## TECHNICAL BULLETIN

**429-18-58**

**MODEL AFFECTED:** 429

**SUBJECT:** BELLCRANK ASSEMBLIES 429-001-523-101, 429-001-523-103, 429-001-532-101, AND 429-001-532-103, UPGRADE OF.

**Figure 1 - Bellcrank Assemblies**

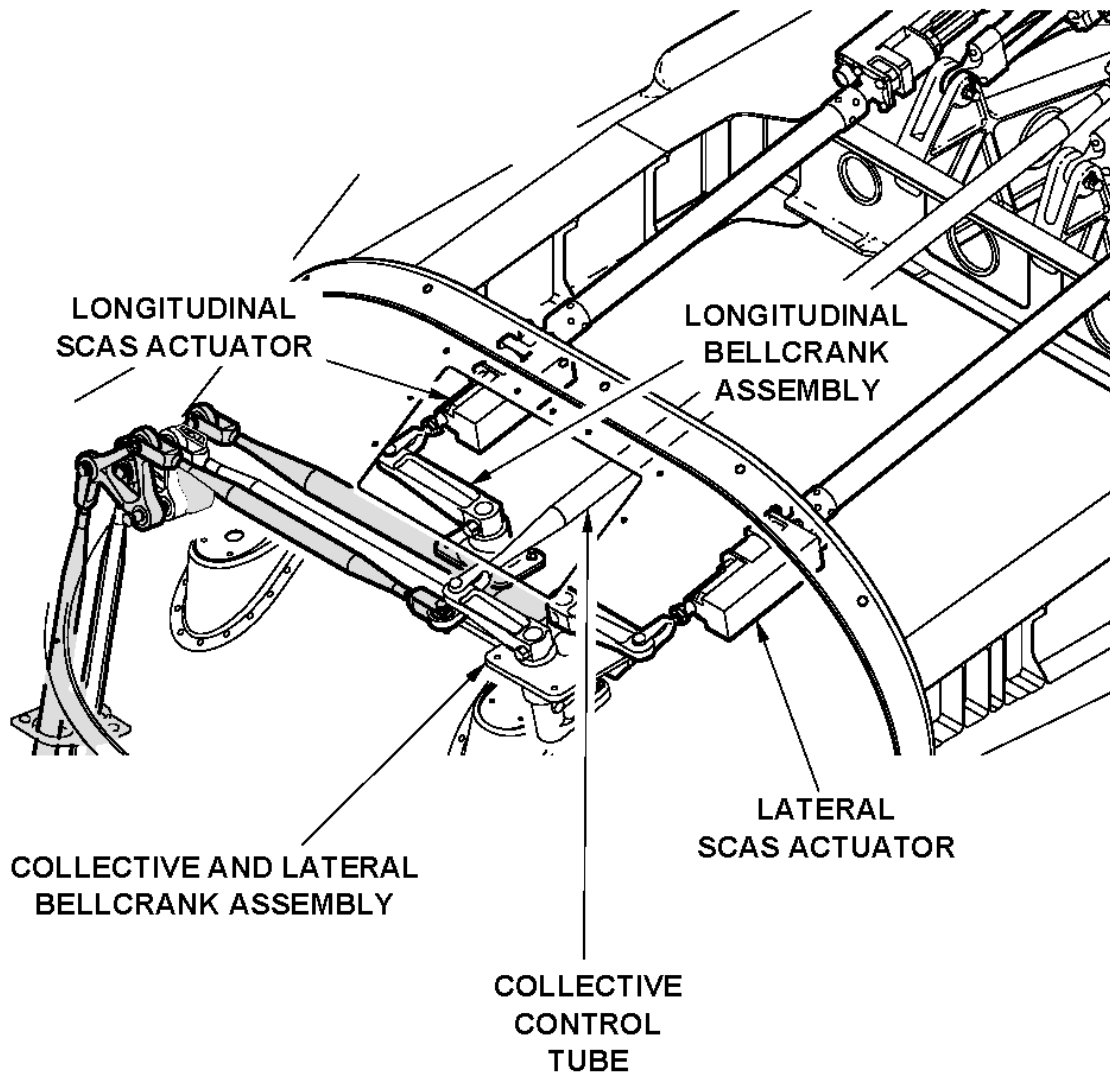
1. Prepare helicopter for maintenance.
2. Remove the 429-001-523-101/-103 and the 429-001-532-101/-103 roof mounted bellcrank assemblies (BHT-429-MM-1 Chapter 67).
3. Identify and record the assembly part number by reading the ink stamp on the lower surface of the bellcrank assembly's support.
4. Disassemble the 429-001-523-101/-103 and the 429-001-532-101/-103 roof mounted bellcrank assemblies.
5. Discard the six MS27646-41 pivot bearings (1, Figure 2).
6. Remove and discard the six MS27643-4 arm assembly bearings (2) and the sleeves 120-13-4A (BHT-ALL-SPM).

**Figure 2 – Bellcrank Assembly Details**

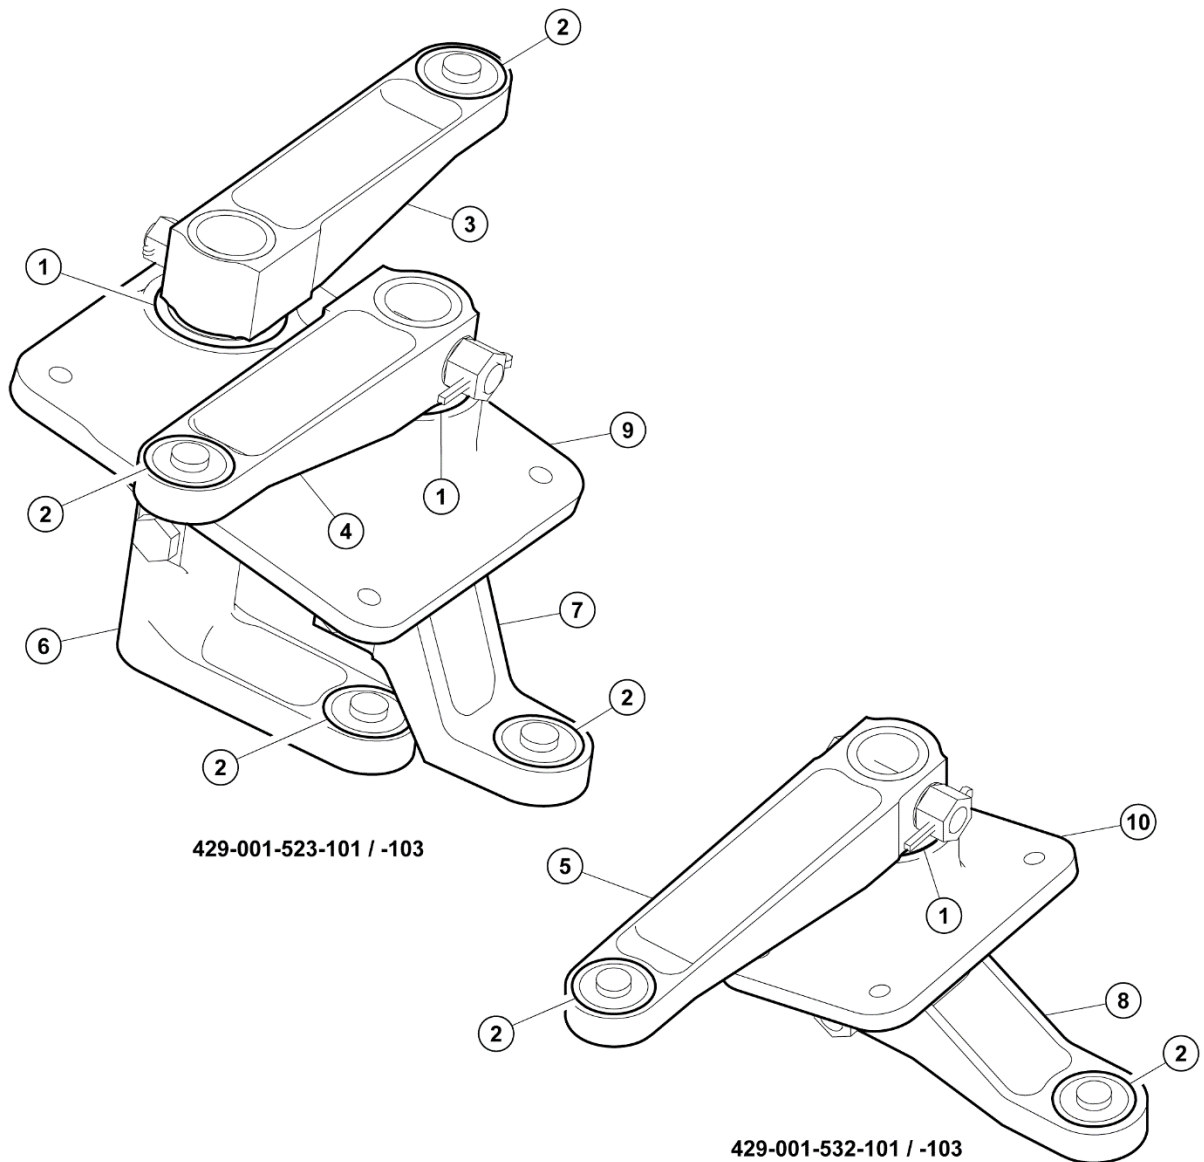
7. Install the 120-13-4A sleeves and the 429-301-012-101 bearings in the upper arm assemblies (3, 4, and 5) (BHT-ALL-SPM).

10. Install the 120-13-4A sleeves and the 429-301-012-101 bearings in the lower arms (6, 7, and 8) (BHT-ALL-SPM).
11. Using a black permanent ink pen, re-identify the three lower arms (6, 7, and 8) by striking through the "-101" and writing "-105FM". The lower arm assemblies should now be identified as 429-001-526-105FM, 429-001-528-105FM and 429-001-531-105FM.

**Figure 3 – Bellcrank Assembly Details**

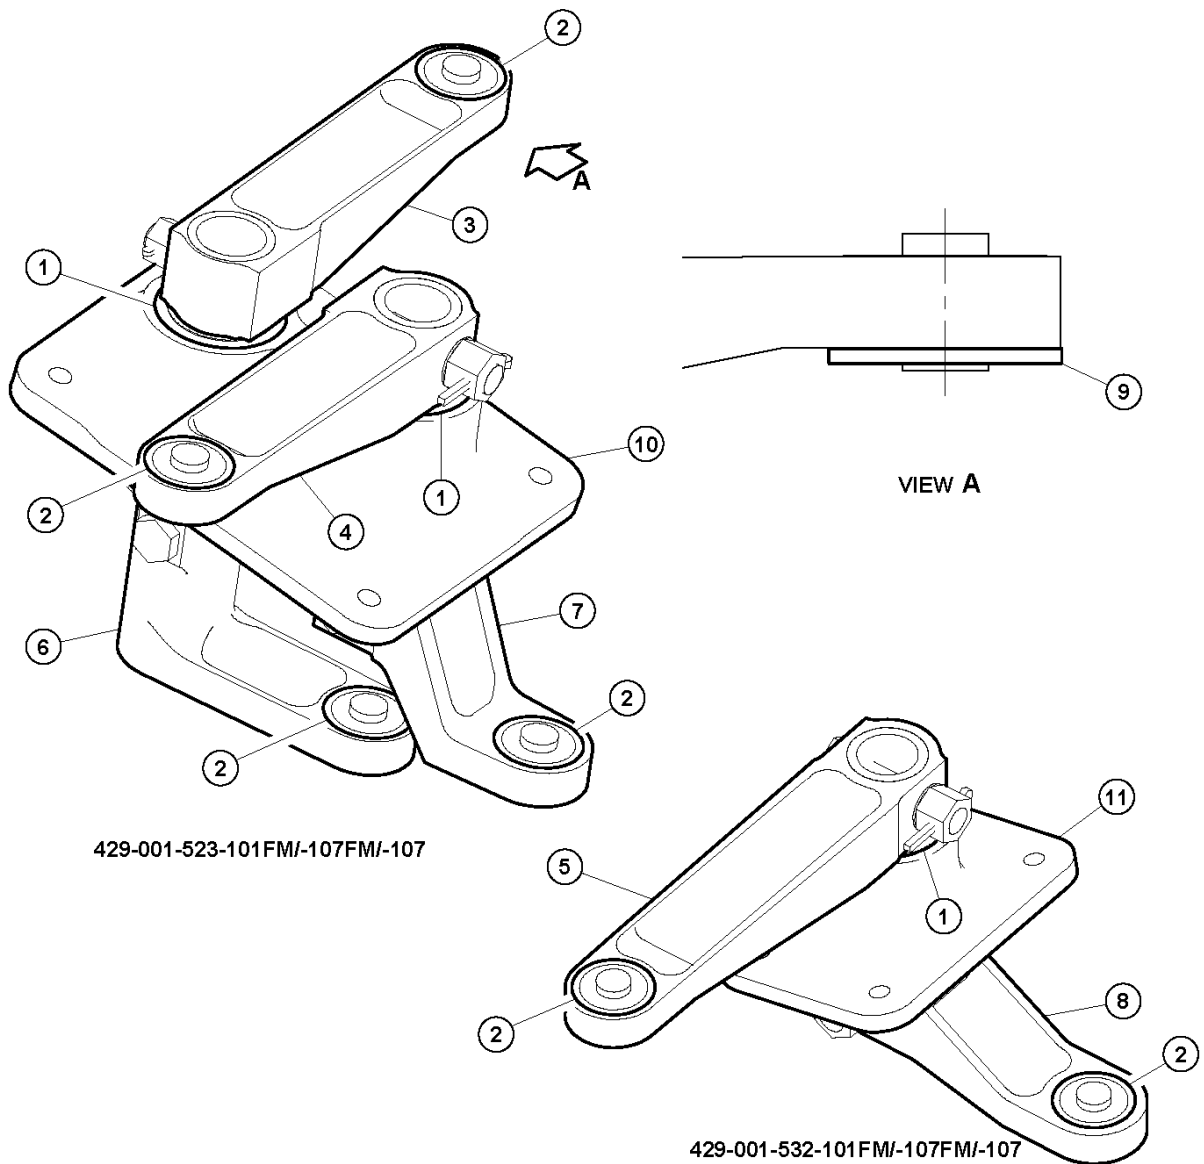
8. Lightly abrade the lower surface of the upper arms (3, 4, and 5) and bond the 140-055A7 (9) washer to the lower surface of upper arms using adhesive (C-301). After the adhesive cures, edge seal the washer using sealant (C-251) (Figure 3, View A).

9. Using a black permanent ink pen, re-identify the three upper arms (3, 4, and 5) by striking through the "-101" and writing "-107FM". The upper arm assemblies should now be identified as 429-001-525-107FM, 429-001-527-107FM, and 429-001-530-107FM.

12. Assemble the roof mounted bellcrank assemblies using the 429-301-010-101 pivot bearings (1) (BHT-429-MM-1 Chapter 67).
13. If the bellcrank assemblies are identified as 429-001-523-101 and 429-001-532-101, using a black permanent ink pen, re-identify them by adding "FM" after the part number. If the bellcrank assemblies are identified as 429-001-523-103 and 429-001-532-103, using a black permanent ink pen, strike through the "-103" and add "-107FM". The bellcrank assemblies should now be identified as 429-001-523-101FM and 429-001-532-101FM or 429-001-523-107FM and 429-001-532-107FM.

**Revision A** of this Technical Bulletin corrects the location of the 140-055A7 washers. The washers should be bonded to the lower surface of the upper three bellcrank assembly arms. Bellcranks received new from Bell spares had the washers orientated correctly. Bellcranks received reconditioned from Bell spares or those that have been modified as per the original issue of this Technical Bulletin will have the washer bonded to upper surface. Bell recommends removing the washers and bonding new washers to the lower surface as per step 8 of this Technical Bulletin.
